Access Compliance Report

Public Rights-of-Way

(Curb Ramps)

Intersection ID: 10016404	Main Street: MILHAVEN_LN	Cross Street: N/A	Location: W
ADA ID: 8E25581E9911	Ramp Type: Directional	Initial Pass/Fail: Pass	Overall Compliance: No
			Severity Score: 15

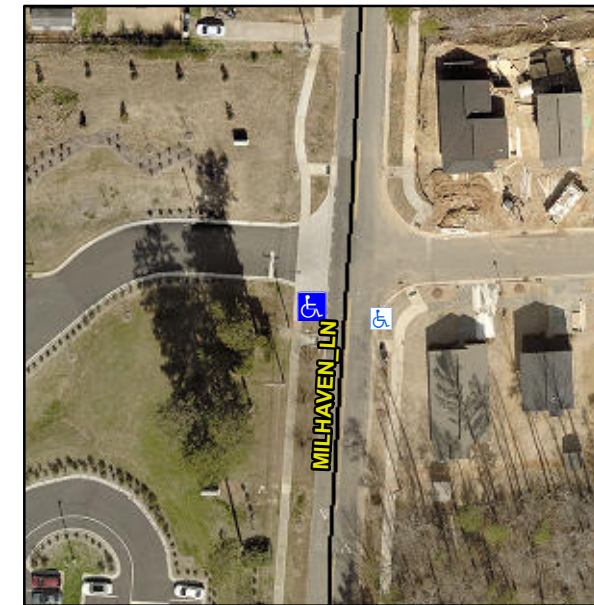
NO CURB

**Not Found, R304.2.2-Perp, R304.3.2-
Para, R305.1.4, R305.2, R302.7,
R302.7.2, R304.5.4**

**Remove & Replace Entire Ramp.
Remove & Replace Gutter.**
